Proposed Development 22 – 26 Albert Street, Freshwater

The S96 Application proposes minor modifications as follows:

S96 APPLICATION SCHEDULE OF MODIFICATION

02 BASEMENT 1 PLAN
SCALE: 1:200

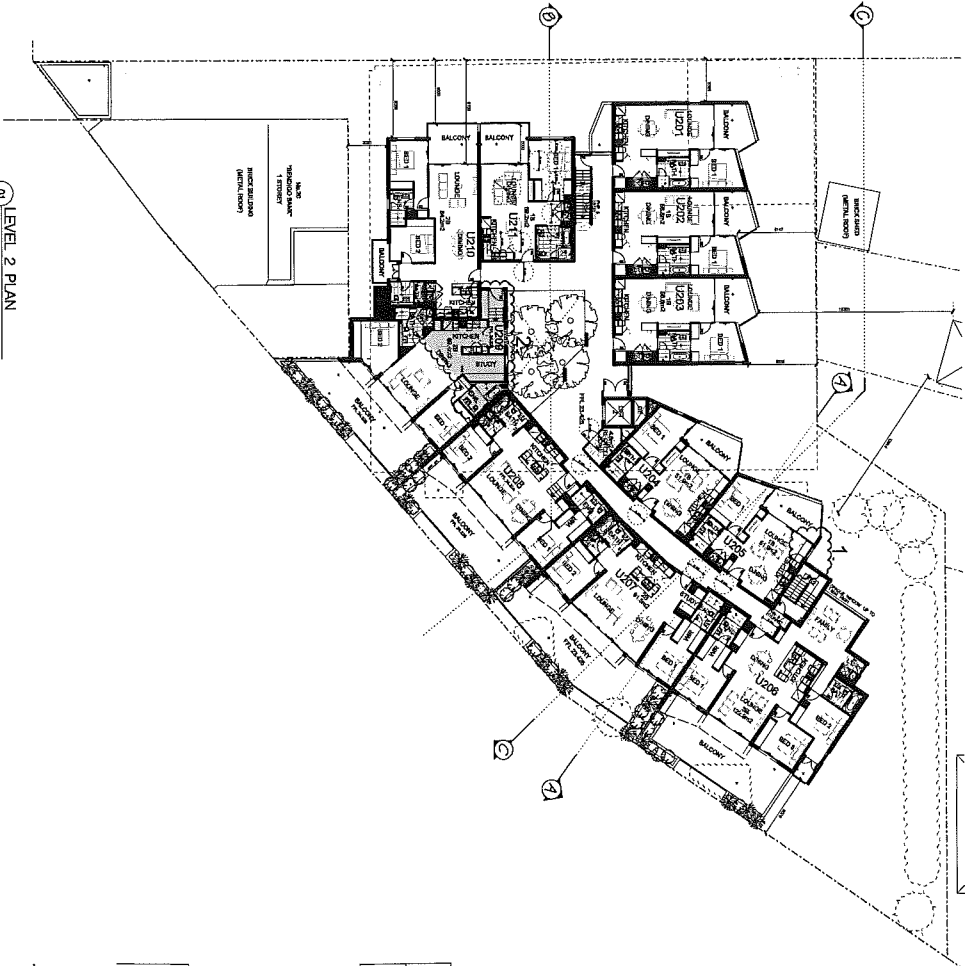
1. RETAIL LIFT RELOCATED, ADDITIONAL RETAIL LIFT ADDED TO COMPENSATE FOR REMOVAL OF PARKING WALK ON BASINMENT LEVEL, 1 CAR PARKING & PLANT ROOM REARRANGED AS A RESULT, NUMBERS TO WHERE RETAIL LIFT ORIGINALLY WAS, ACCESSIBLE, MOVING WALK MOVED TO BE CLOSER TO THE MOVING WALK REMOVED.
2. F33 RELOCATED FROM NORTH WESTERN CORNER OF SITE TO ABOVE UNDER SOUTH WESTERN CORNER OF THE CARPARK TO EXIT CLOSER TO THE STREET, PLANTROOM ADDED.
3. MOVING WALK REMOVED, EXTENT OF BASINMENT LEVEL, 1 REDUCED, PLANTROOM MOVED TO WHERE RETAIL LOBBY ORIGINALLY WAS.

01
SCALE: 1:200

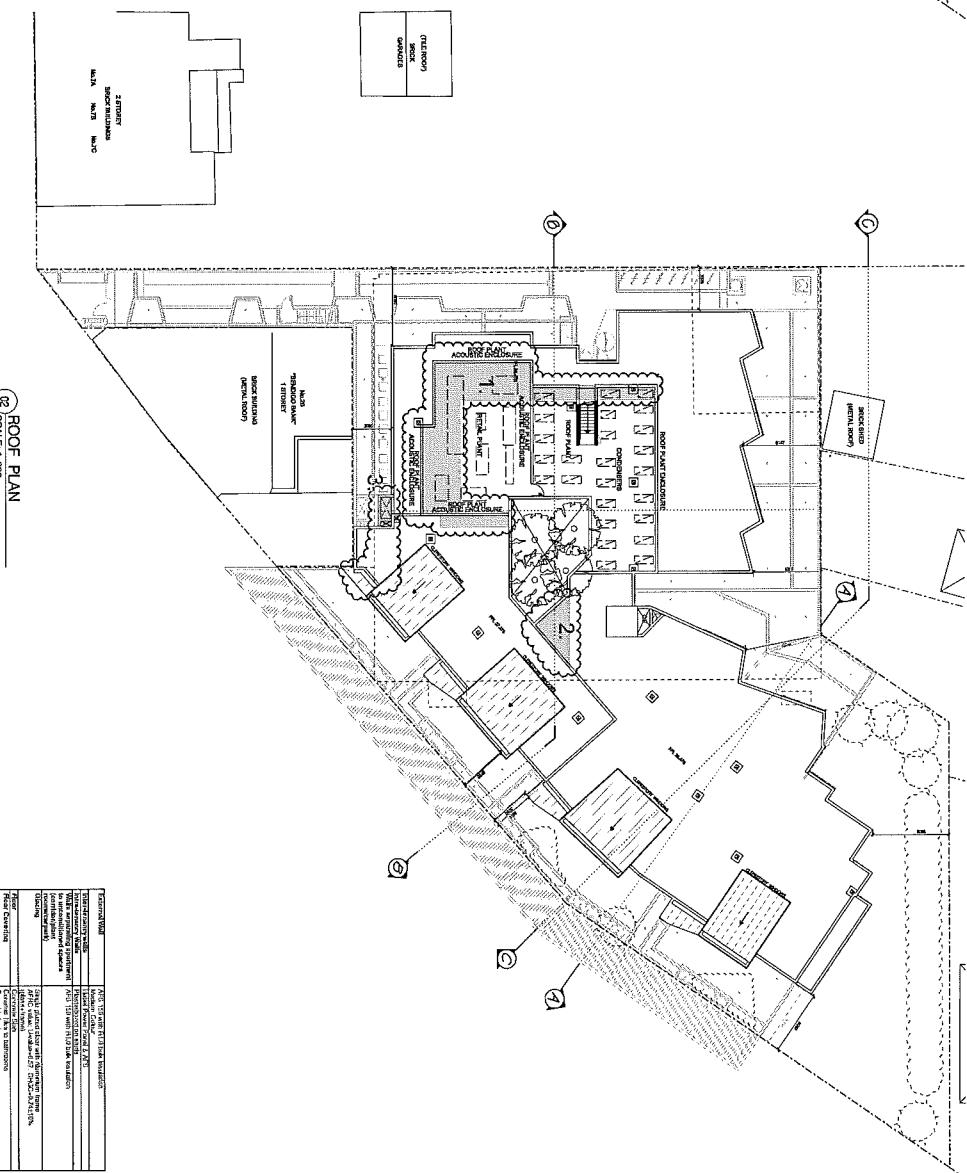
1. ROOF PLANT EXPANDED TO ACCOMMODATE RETAIL SERVICES AND MAX. 2M HEIGHT ACOUSTIC SCREEN ADDED TO PLANT AREA.

2. VOID REDUCED TO PROVIDE ADEQUATE HOODING OVER LOBBY.
3. RETAIL KITCHEN EXHAUST AND CAR PARK RISER ADDED & ROOF FORM AMENDED TO MATCH APPROVED ELEVATION

ELEVATION - ALBERT STREET

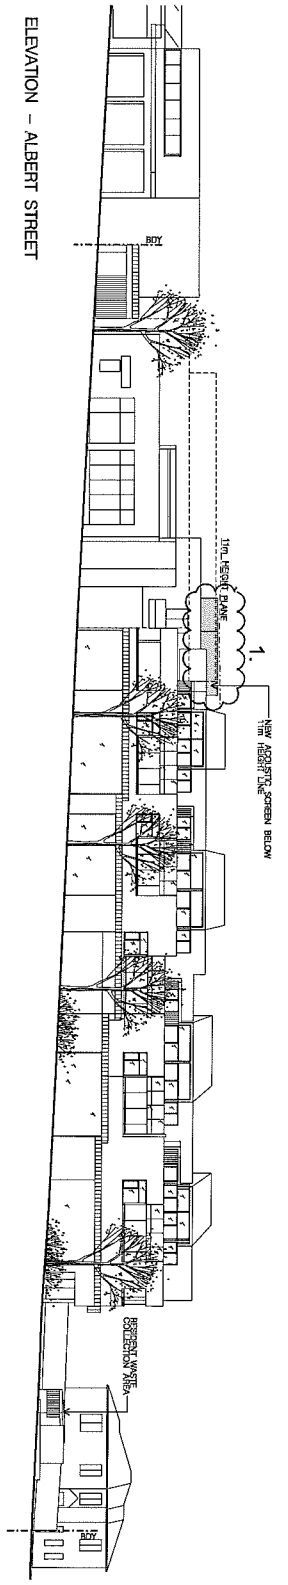
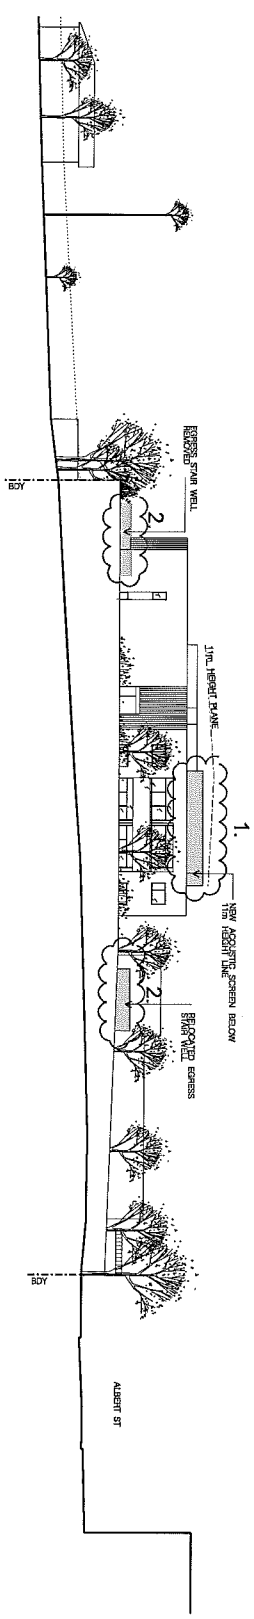
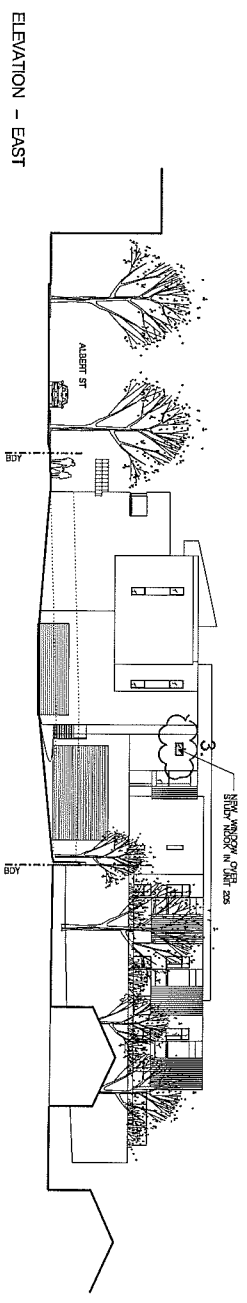
1. ROOF PLANT EXPANDED TO ACCOMMODATE RETAIL SERVICES AND MAX. 2M HEIGHT ACROUSTIC SCREEN ADDED TO PLANT AREA.
2. FSS RELOCATED TO BE CLOSER TO STREET.
3. HIGH LEVEL WINDOW ADDED TO STUDY NOOK IN UNIT 205 ON NORTH EASTERN WALL.
